Service Bulletin

Bulletin No.: PI1377

Subject: Rubbing Noise in Steering Column when Turning Steering Wheel

Models: 2014 Cadillac ELR

4035140

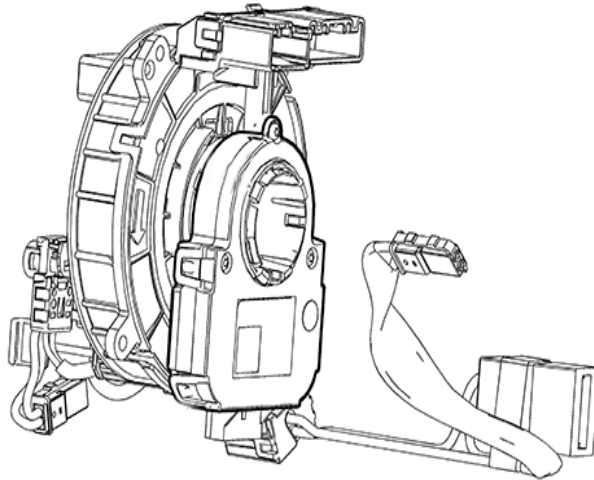
Some customers may comment on hearing a rubbing noise from the steering column while turning the steering wheel.

This may be caused by the steering angle sensor rubbing on the steering wheel airbag coil (SIR Coil).

4035997

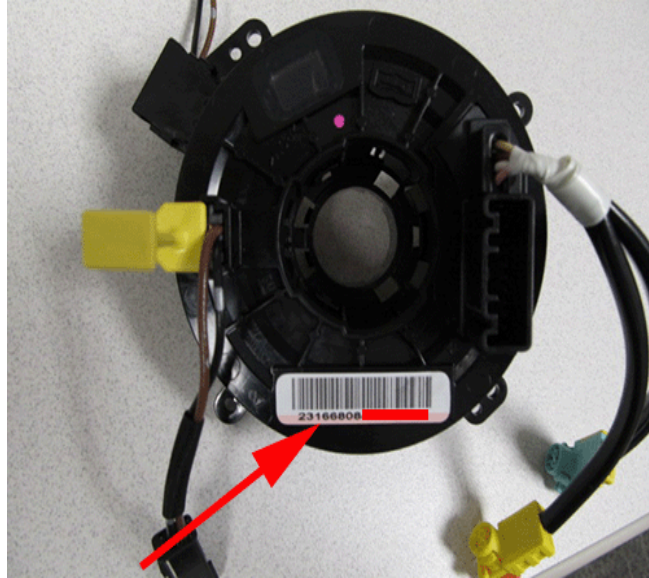
- Remove the steering wheel and check the part number on SIR coil. Refer to Steering Wheel Airbag Coil Replacement in SI.

- If the first eight numbers are part number 23127905 on the SIR coil, replace the SIR coil with part number 23166808. Refer to Steering Wheel Airbag Coil Replacement in SI.
- If a newer SIR coil is already installed on the vehicle (part number 23166808), replace the steering angle sensor with part number 13589991. Refer to Steering Angle Sensor Replacement in SI.
